ADDENDUM 5

DATE: December 27, 2017

Contract 17-C-00039; Breckenridge Pumping Station Rehabilitation

DEMOLITION PLAN

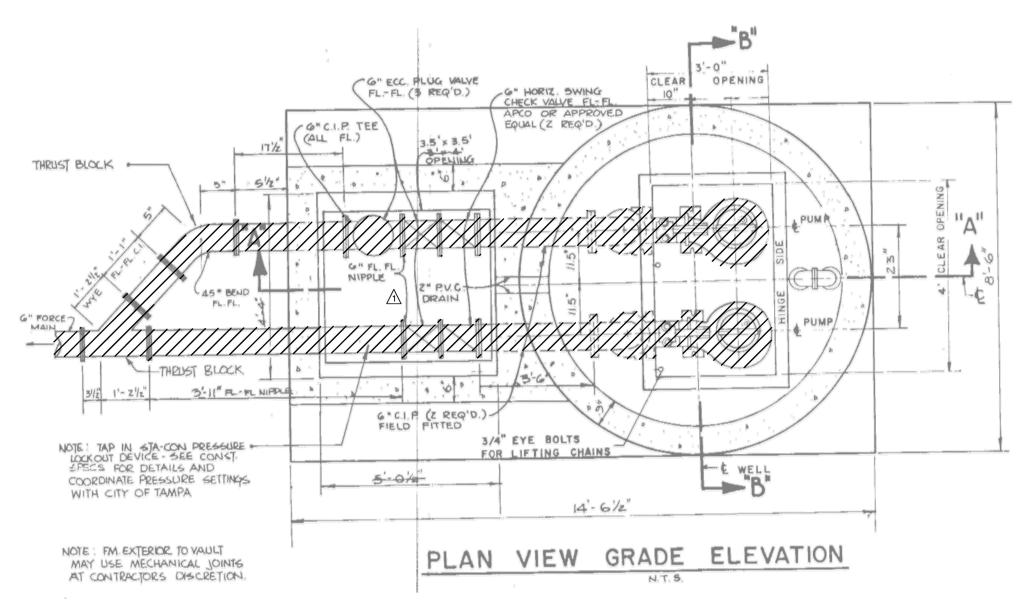
No.	DATE	REVISIONS	DES: VT
3			DRN: MRL
2			CKD:
Λ	11/7/2017	REMOVED HATCHING	DATE:

DEMOLITION SECTION A-A

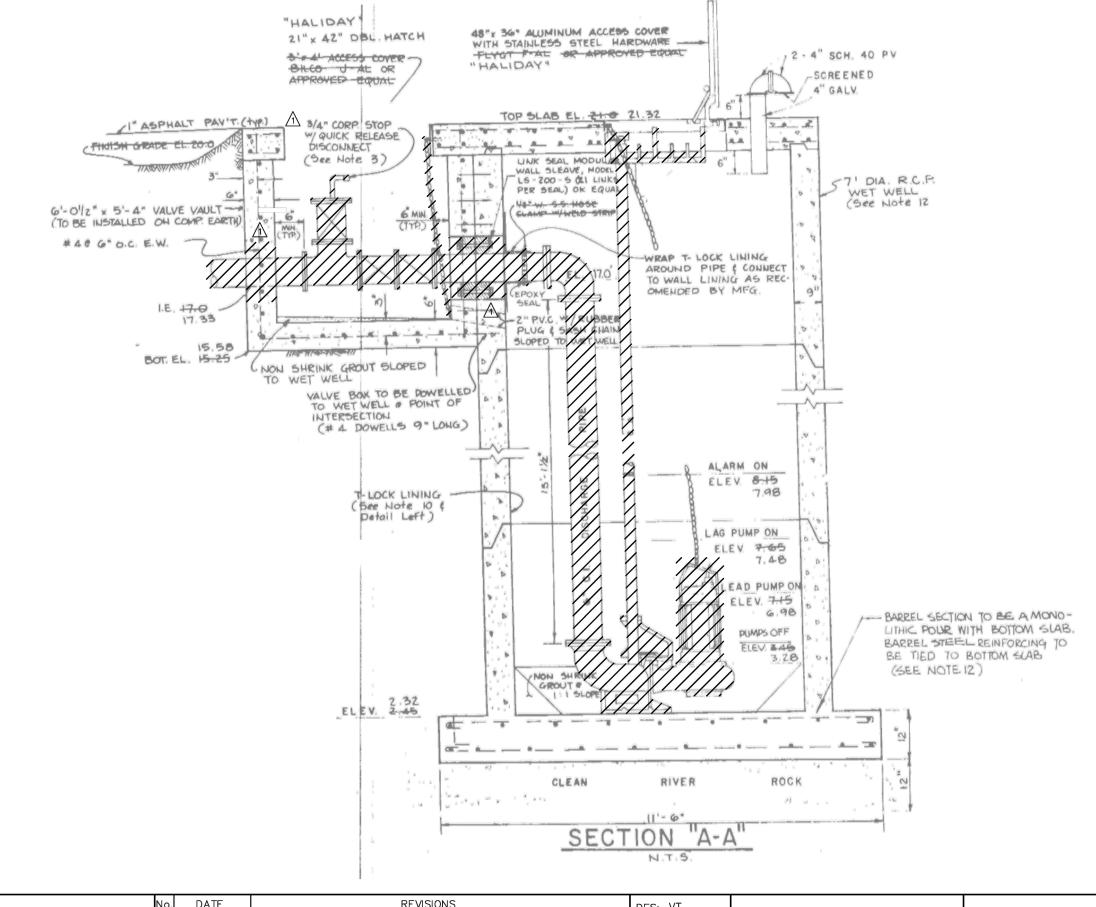
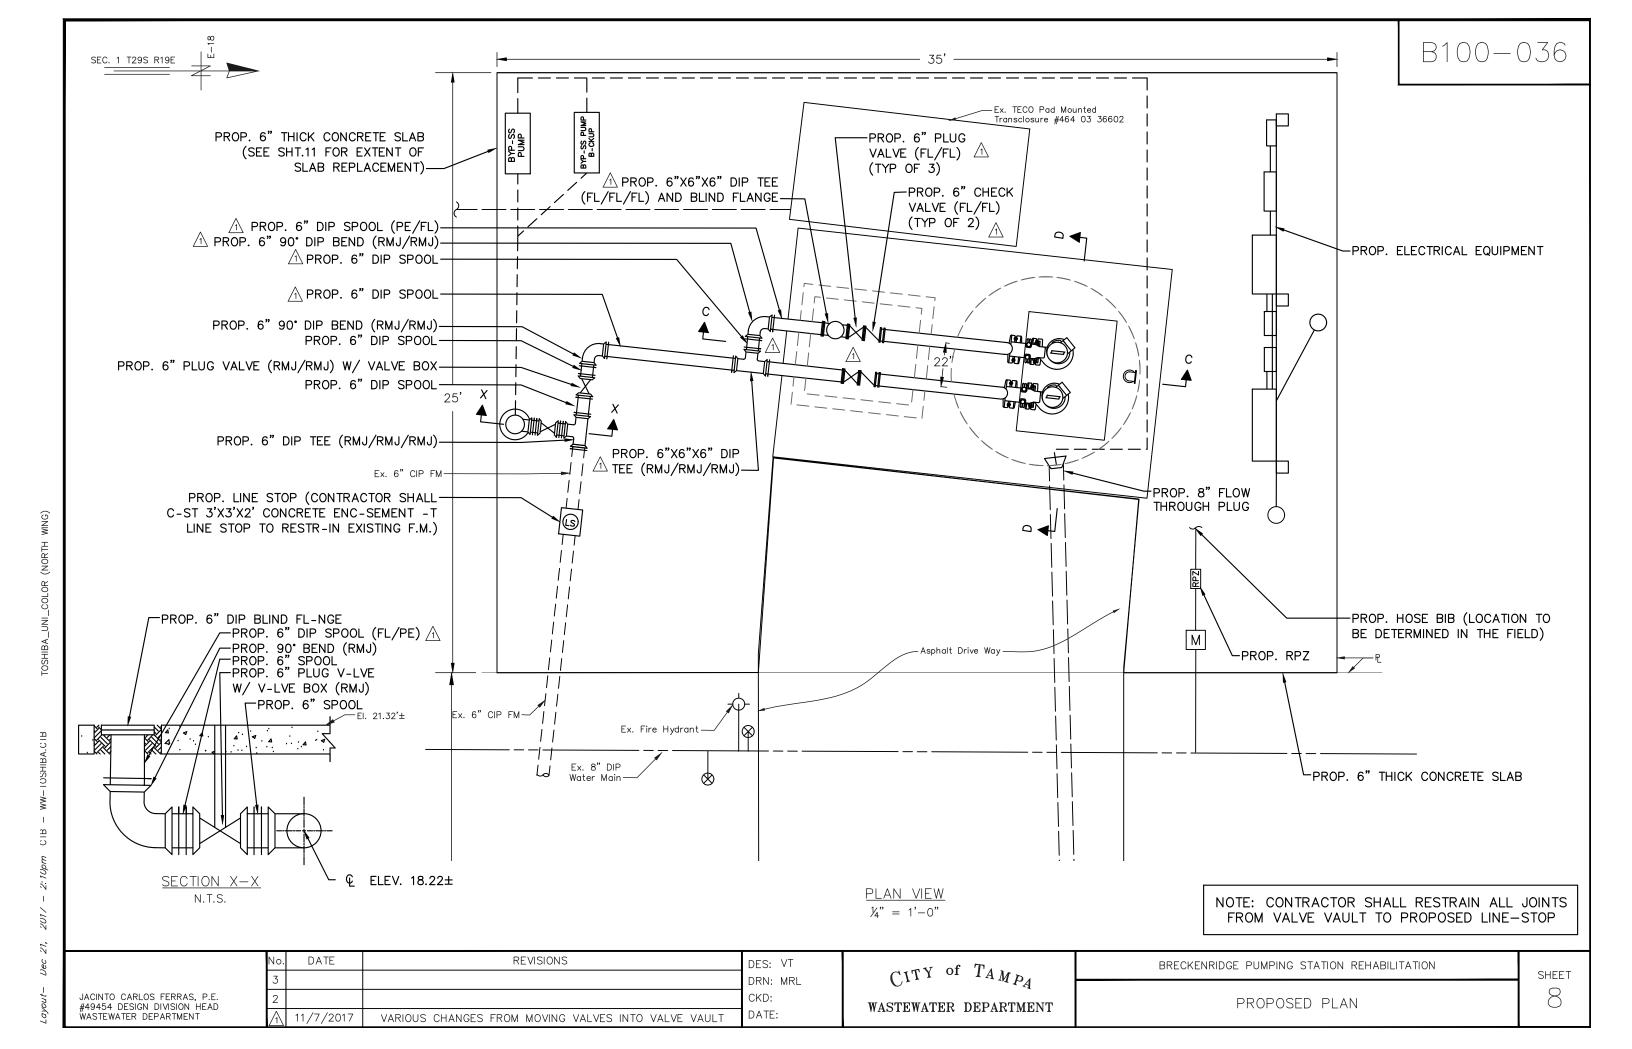
11/13/2017 REMOVED HATCHING FROM ACCESS COVER AND ADDED TO WALL

PROPOSED SECTION C-C

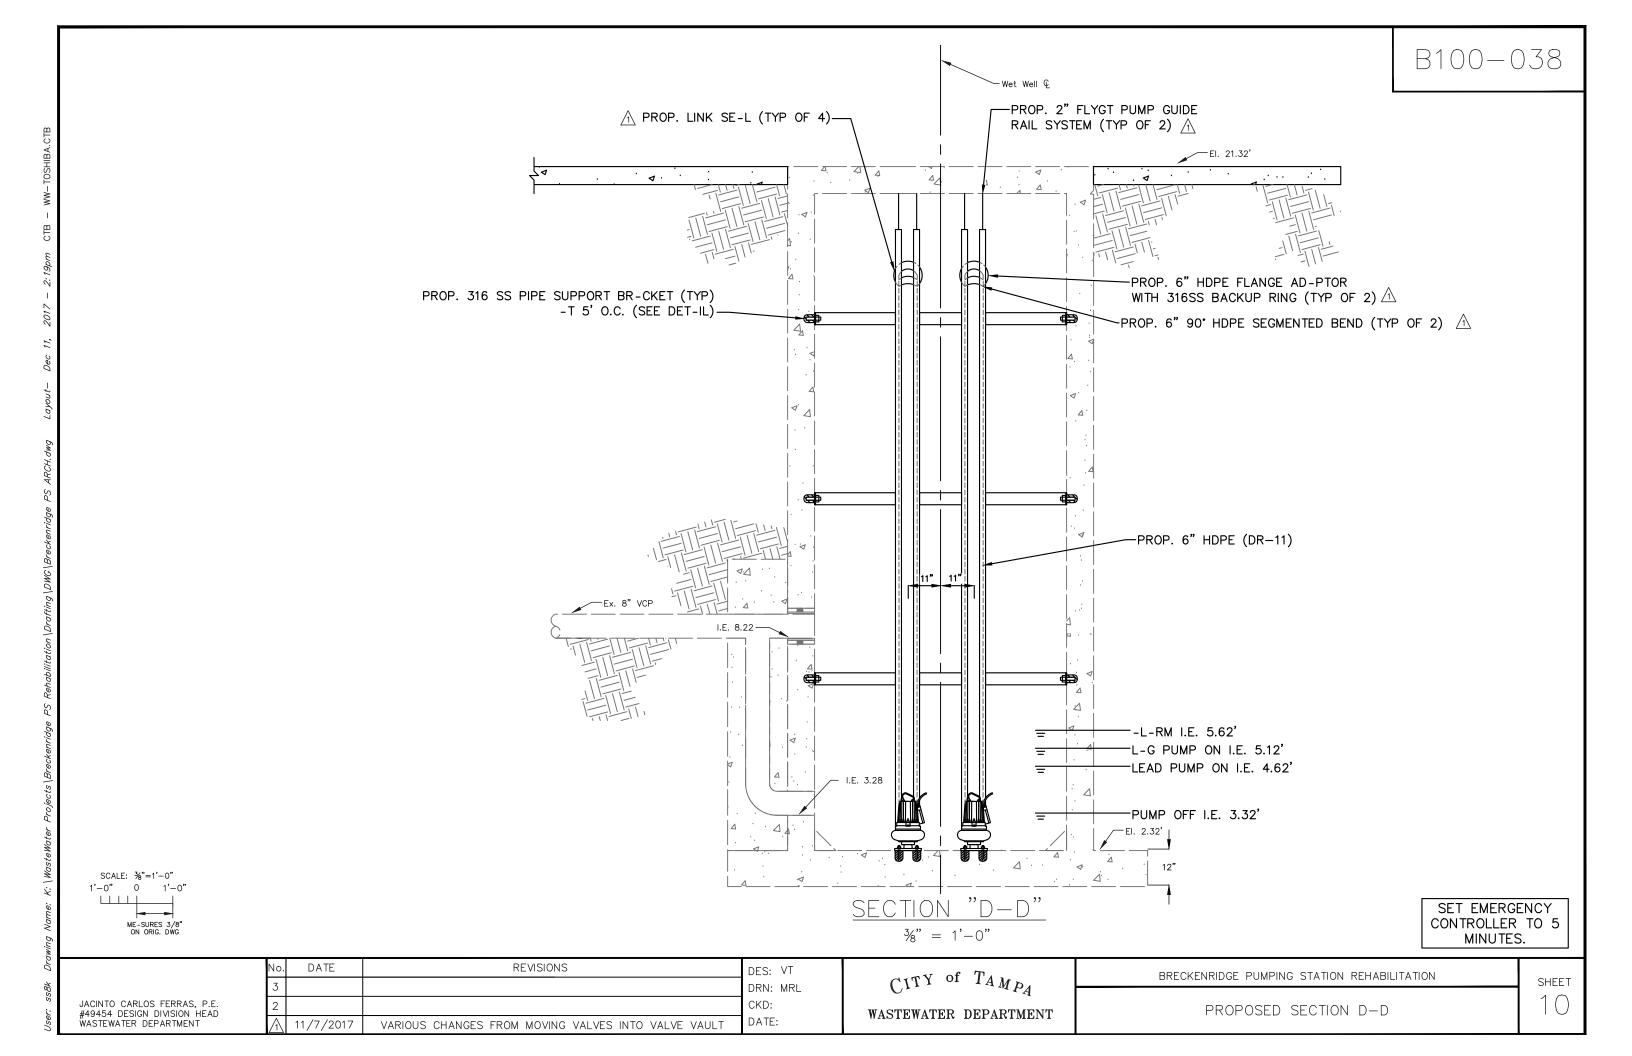
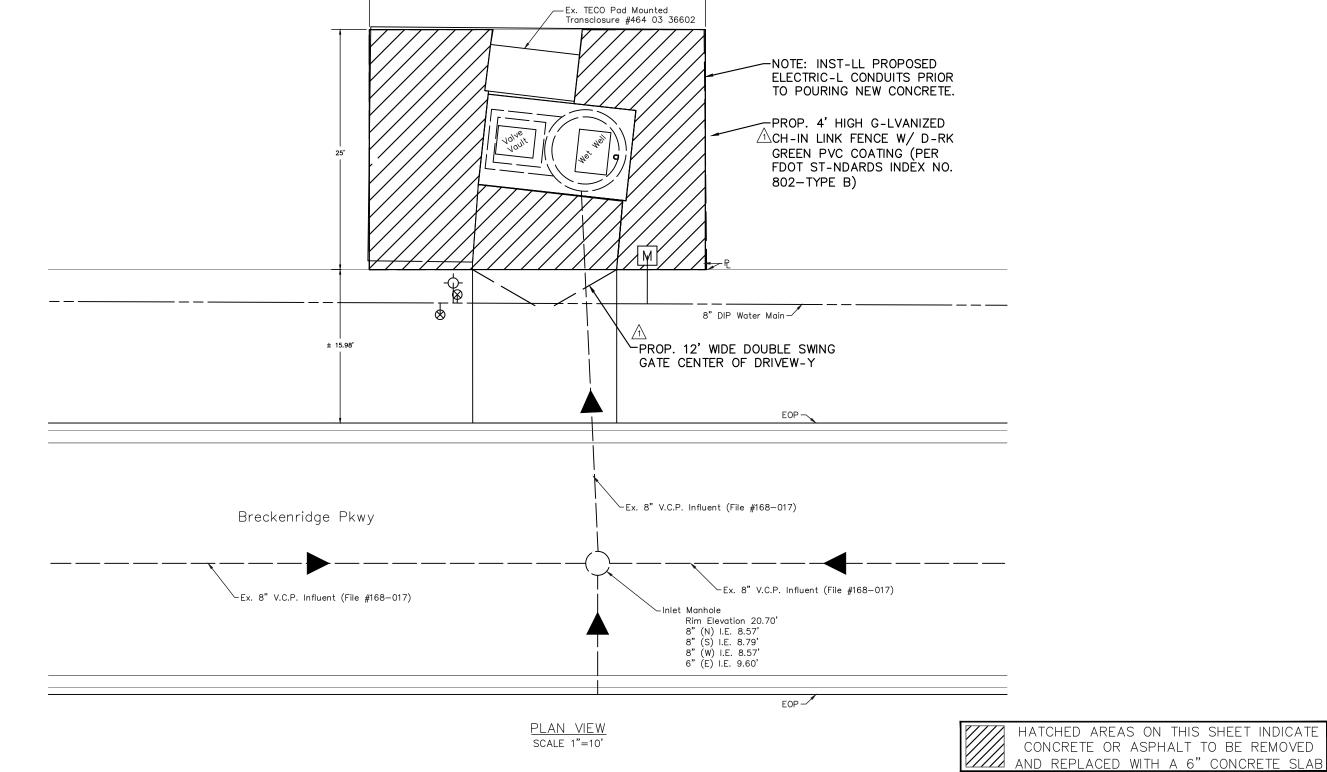
A 11/7/2017 VARIOUS CHANGES FROM MOVING VALVES INTO VALVE VAULT

CONCRETE SITE PLAN

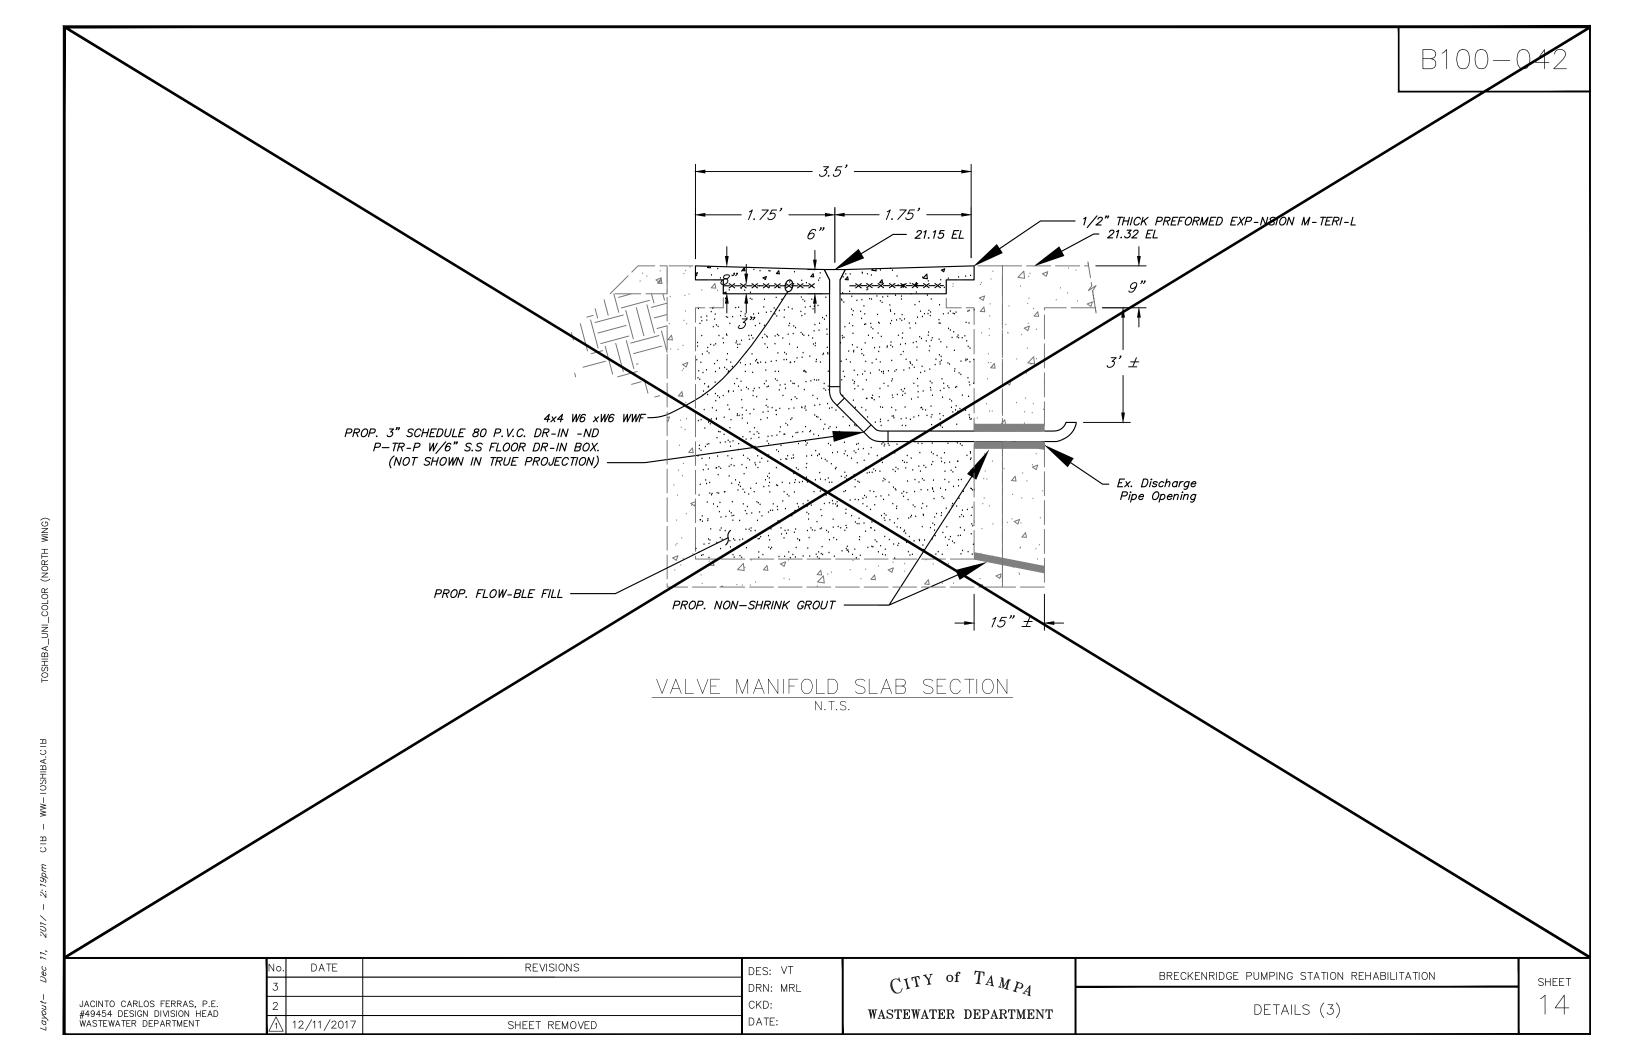
REVISIONS DATE DES: VT DRN: MRL CKD: DATE: /\ 11/13/2017 ADDED FENCE AND GATE

PROPOSED ELECTRICAL PLAN VIEW
1"=5'-0"

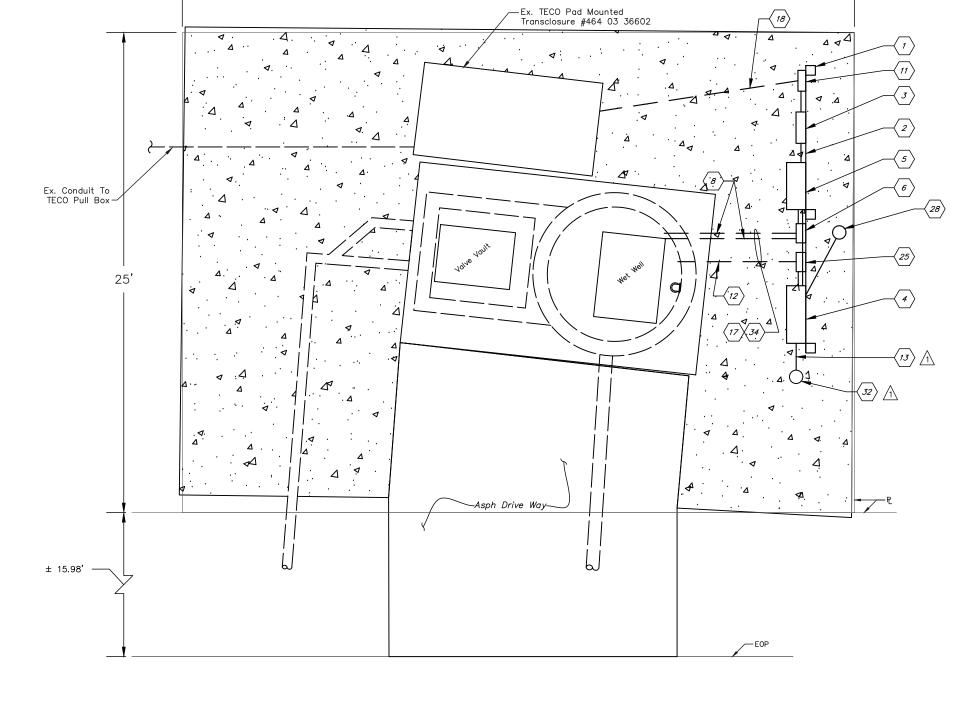
No.	DATE	REVISIONS	DES: LRG	of T	BRECKENRIDGE PUMPING STATION REHABILITATION	1
	3			DRN: MRL	$CI^{TY} \stackrel{\text{of}}{=} I_{AMP_A}$	BREGRENNING TOWN ING STATION RETINDENTATION	SHEET
ROMAN D. KORCHAK, P.E. #42626 ELECTRICAL SECTION HEAD	2			CKD:	WASTEWATER DEPARTMENT	PROPOSED ELECTRICAL PLAN VIEW	E 1
DEPARTMENT OF SANITARY SEWERS	Λ	11/13/2017	RELOCATED SCADA ANTENNA	DATE:	WASIEWAIER DEI ARTMENT

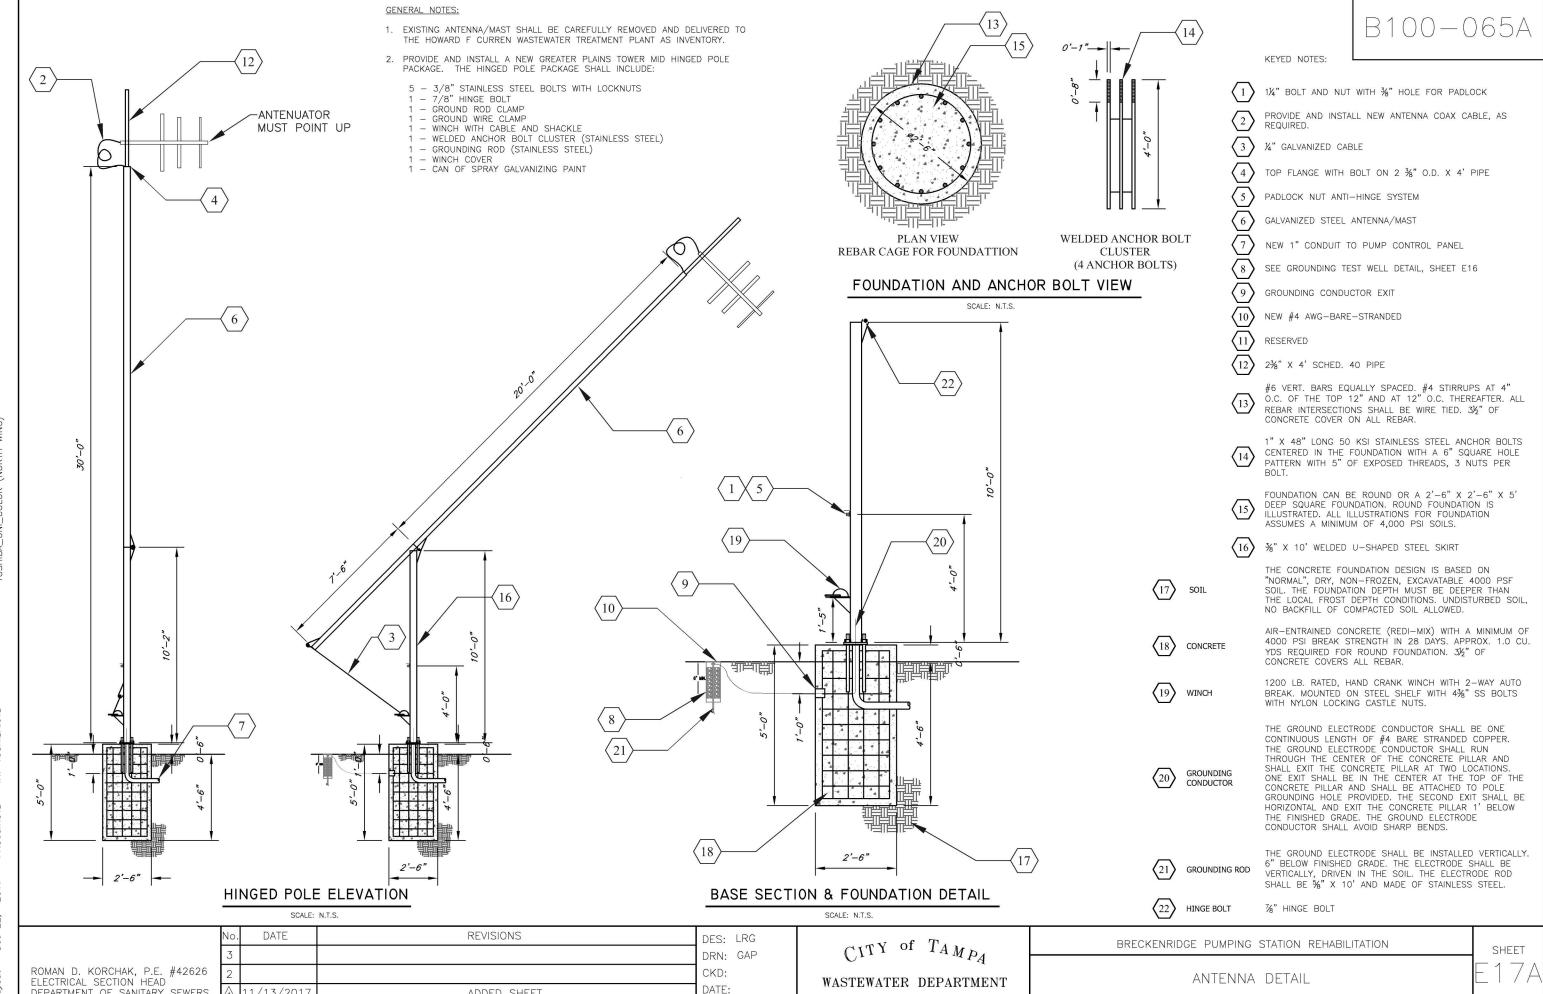
Item 1: Replace Specification, Section 45.01(2)m with the following: m. Remove existing SCADA Antenna and deliver to the City for maintenance inventory. Provide and install new SCADA Antenna with hinged pole.
